ELECTRICAL ADDENDUM #1

ELEC. ADDEN. No.: E1
PROJECT No.: 687
PROJECT NAME: Compass Early Learning Centre, Kirkfield, ON
DATE: March 21, 2025

re: Compass Early Learning & Care - Kirkfield Renovations
- Addendum Number Two

ADDENDUM NUMBER TWO
COMPASS EARLY LEARNING & CARE - KIRKFIELD RENOVATIONS
MARCH 25, 2025

ONTARIO
ASSOCIATION
OF
ARCHITECTS
RONALD A. AWDE
LICENCE #55

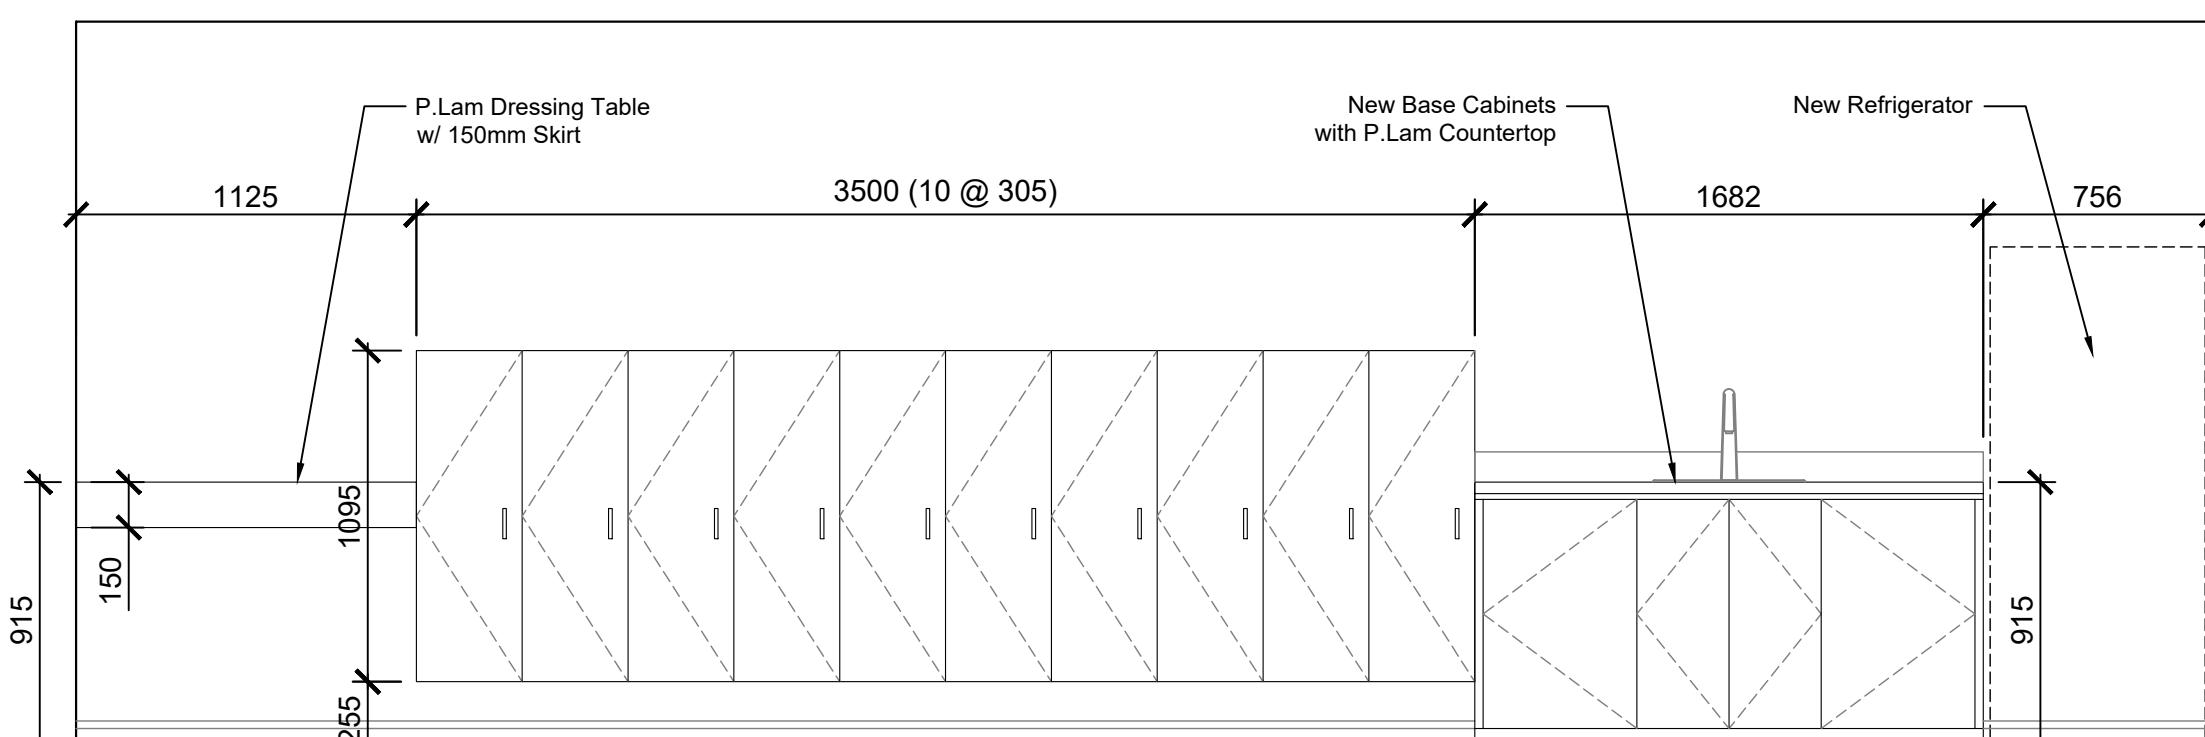
- 11.0** **Note:** All new millwork by this contract based on typical units for upper and lower cabinets per sheet and Elevation A5-03.
- 12.0** **Drawing S1-01: Note:** Provision of tactile indicators at top and base of sloped sidewalk and of handrail guard galvanized steel 1 1/2" diameter top rail 36" AFF, second rail at 24" AFF, bottom rail at 4" AFF.

Electric Heating Schedule

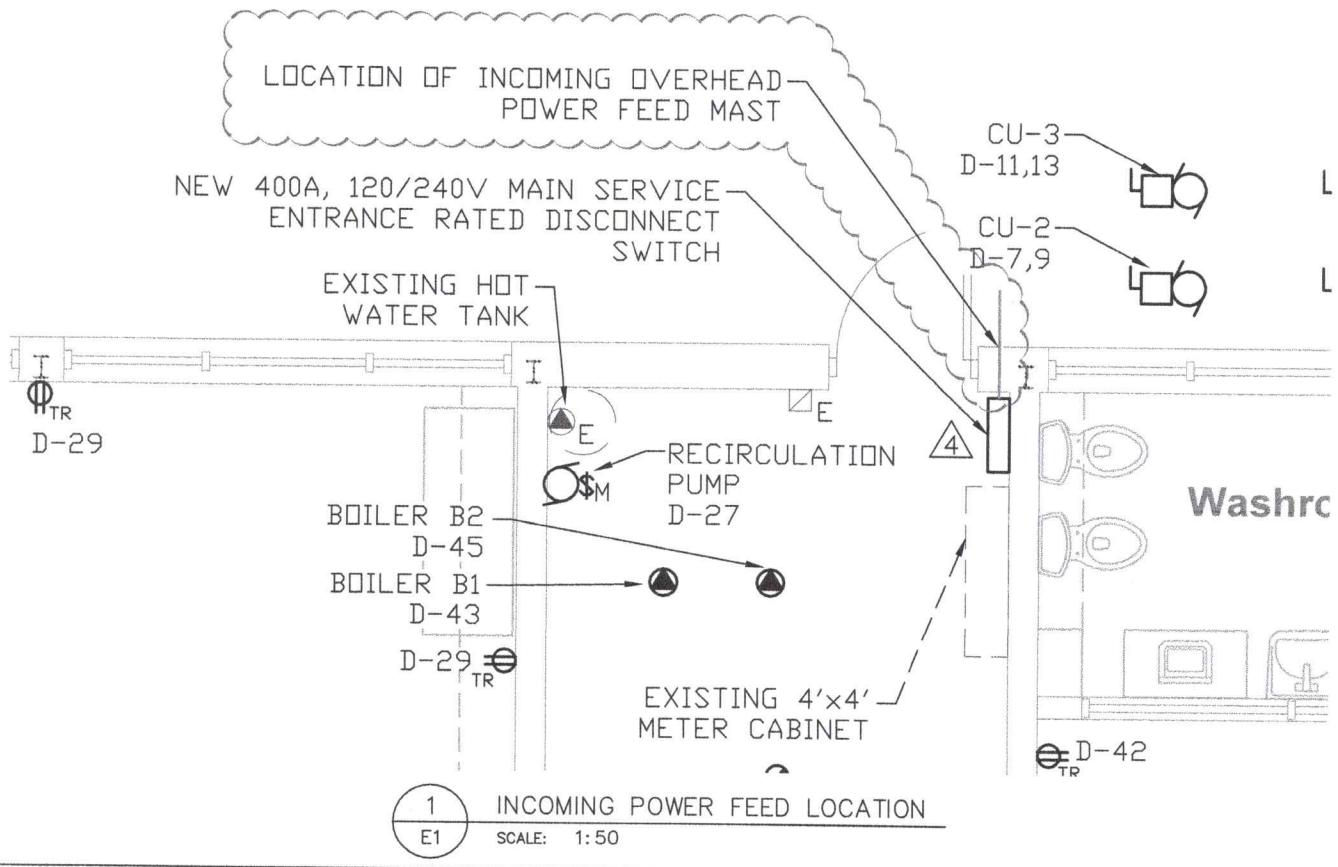
1. The Electric Heating Schedule is missing from Drawing E3. The model numbers for the electric heating equipment are as follows:
 - a. 3kW commercial fan-forced heater, white, 240V, c/w integral tamperproof thermostat, recessed in the wall, Ouellet or approved equal, model number: OAC03000-T.
 - b. 500W baseboard heater, white, 120V, c/w integral thermostat, Ouellet or approved equal, model number: ODB0502-TB6.
 - c. 750W baseboard heater, white, 120V, c/w integral thermostat, Ouellet or approved equal, model number: ODB0752-TB6.
 - d. See schedule on Sketch SK-E1.

2. The building is fed from an overhead feed from a hydro pole on Water Street. The overhead feed goes to an overhead mast, located behind the M&E Room door. The feed then goes down the wall in the M&E Room and into the existing disconnect. See Sketch SK-E1.

SYMBOL	MODEL NUMBER	MANUFACTURER	DESCRIPTION
↑(T)	OAC03000-T	OUELLET OR APPROVED EQUAL	3kW COMMERCIAL FAN-FORCED HEATER, WHITE, 240V, C/W INTEGRAL TAMPERPROOF THERMOSTAT, RECESSED
(T)	ODB0502-TB6	OUELLET OR APPROVED EQUAL	500W BASEBOARD HEATER, WHITE, 120V, C/W INTEGRAL THERMOSTAT
(T)	ODB0752-TB6	OUELLET OR APPROVED EQUAL	750W BASEBOARD HEATER, WHITE, 120V, C/W INTEGRAL THERMOSTAT
